Transmitted by the expert from Japan

Further consideration on AEBS warning timing reflecting the discussion of 2nd TF meeting of AEBS/LDWS

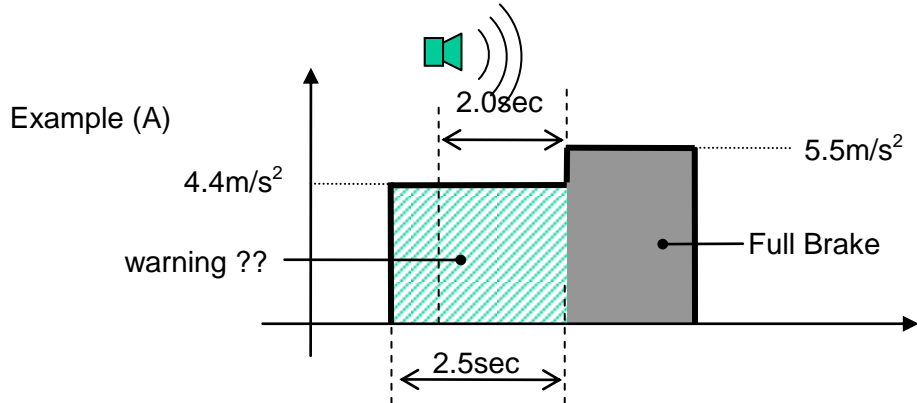
1) It is unnatural to deem hard brake, which is close to full braking, as “warning”.

In a case where the full braking of a vehicle is 5.5m/s^2 , for example 4.4m/s^2 (80% of full braking) will be deemed as “warning”, not as the part of emergency braking.

2) From an basic principal that if a vehicle operates any of its maneuver that is not intended by the

driver, some kind of warning shall be provided prior to this automatic operation.

However, this proposal A cannot exclude the possibility that automatic operation starts before warning.

This proposal permits applying hard brake for 0.5sec. without providing warning as shown in example (A) below.

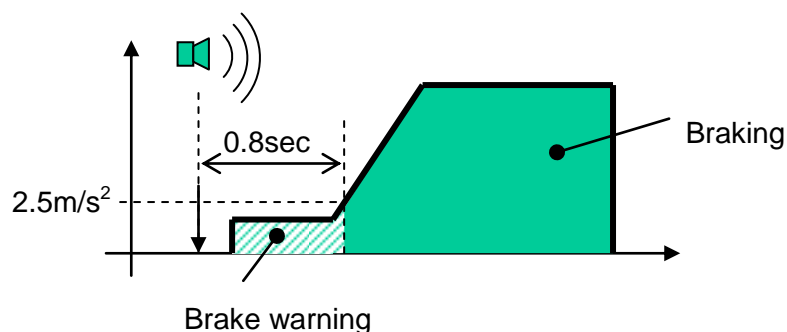
Provide warning at latest 0.8 sec prior to the activation of service brake system.

Brake warning is not included as activation of service brake system.

It is permitted to warn the driver simultaneously of service brake application when the emergency situation such as when the system detects the sudden cut-in of a vehicle.

This proposal can guarantee to warn the driver before automatic emergency braking basically.

[The definition of warning brake]:

The deceleration shall be equal or less than 2.5 m/s².
